# UNITED STATES PATENT AND TRADEMARK OFFICE

10/568,787

<b>Office Action Summary</b>	<b>Application No.</b> 10/568,787	<b>Applicant(s)</b> EMBLIN, ALAN GAYNE	
	<b>Examiner</b> JESSIE FONSECA	<b>Art Unit</b> 3633

## **DETAILED ACTION**

Fig. 4: Ruff et al. (US 4,067,155)

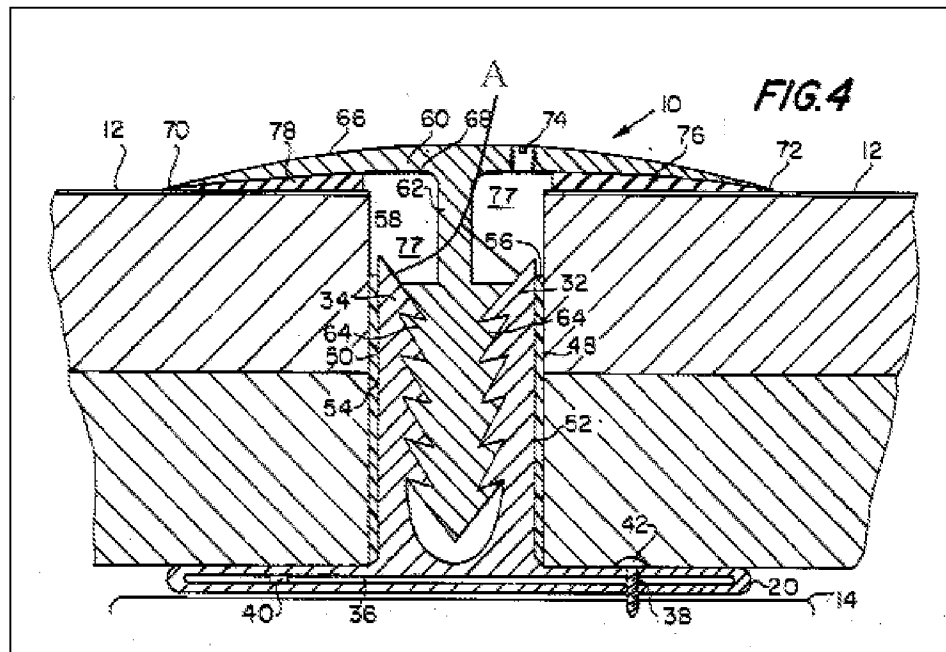
With regard to claim 60: Ruff et al. discloses a stud (16) capable of use in panel form work for solid filled walls, the stud comprising:

a head (20) formed as a strip, the strip having a relatively broad flat surface (figs. 1 and 3-4) adapted to directly abut against and be bonded and/or fastened to an inner face of a panel facing sheet,

a pair of spaced, opposed flanges (22, 24) formed along and extending away from a central portion of the head (20), the flanges formed integrally with the head such that the flanges (22, 24) and a portion of the head (20) spanning between the flanges (22, 24) define a recess with inwardly directed teeth (figs. 1 and 3-4) capable engagement of a spacer element, and

each flange (22, 24) having an out-turned terminal lip (A), the out-turned terminal lips (A) defining a widening of the recess. Note [Dictionary.com](http://Dictionary.com) defines a *lip* as “any edge or rim.” Accordingly, the lip (A) of Ruff et al. is the edge of the flange, which shows the lip turning (angled) away to create a widening of the recess. Examiner notes the claim does not specifically define how the lip of the flange is outwardly turned other than the lip defining a widening of the recess, which is taught by Ruff et al.

With regard to claim 61: Ruff et al. further discloses the width of the head (20) is substantially greater than the spacing of the flanges (22, 24) on the central portion of the head (figs. 1 and 3-4).

With regard to claim 62: Ruff et al. further disclose the width of the head (20) is approximately seven times the spacing between the flanges (22, 24) (fig. 4)

With regard to claim 64: Ruff further discloses the cross sectional configuration, formed by the strip and the pair of flanges is substantially T-shaped (fig. 1).
